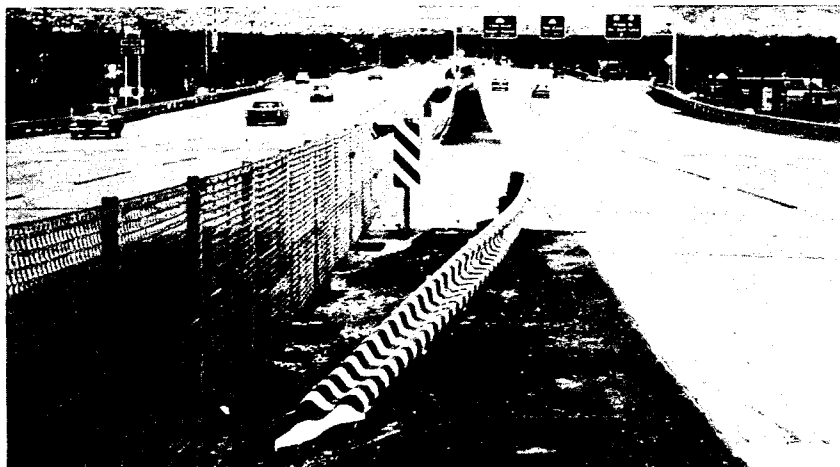
Mr. W. MAY. Again they have installed one, two, three different types of barriers because of this median, because of this construction of the bridge.

Mr. W. MAY. I am sure. That represents real hazardous location the way it exists.

Perhaps they could level that concrete parapet or median barrier and carry the cable barrier through the structure and remove this small piece of guardrail we see in the right. Again, the Bureau would participate in this?

Mr. W. MAY. What do you think of my suggested correction?

Mr. TURNER. That would be one I would want to look at.
